State of New Mexico  
Energy, Minerals and Natural Resources

WELL API NO. 30-015-37588
5. Indicate Type of Lease STATE <input checked="" type="checkbox"/> FEE <input type="checkbox"/>
6. State Oil & Gas Lease No.
7. Lease Name or Unit Agreement Name Elk Wallow 11 State
8. Well Number 001H
9. OGRID Number 5380
10. Pool name or Wildcat Pierce Crossing, Bone Spring, East
11. Elevation (Show whether DR, RKB, RT, GR, etc.) 3039' GR

**SUNDRY NOTICES AND REPORTS ON WELLS**  
(DO NOT USE THIS FORM FOR PROPOSALS TO DRILL OR TO DEEPEN OR PLUG BACK TO A DIFFERENT RESERVOIR. USE "APPLICATION FOR PERMIT" (FORM C-101) FOR SUCH PROPOSALS.)

# Elk Wallow 11 State #001 Current and Proposed WBD's

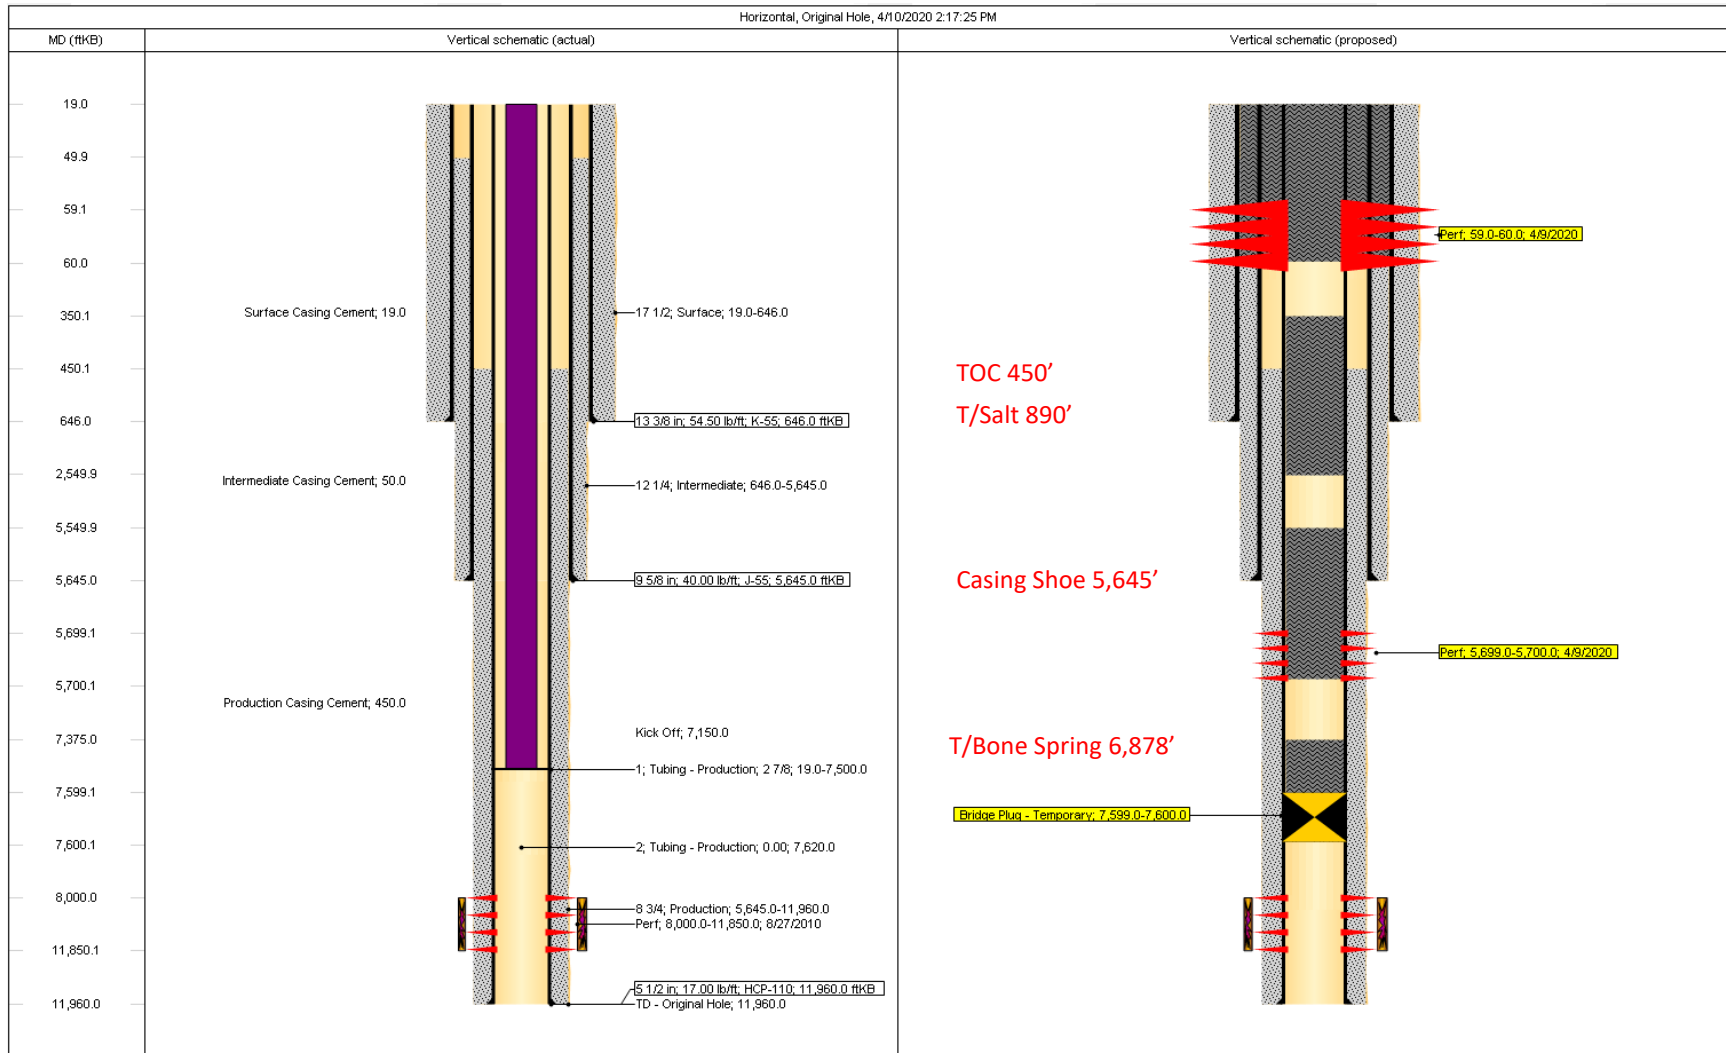
spot 25sx cmt @ 7150' must tag at 6900' - top of BS

MUST BE PLUGGED BY 5/1/2021
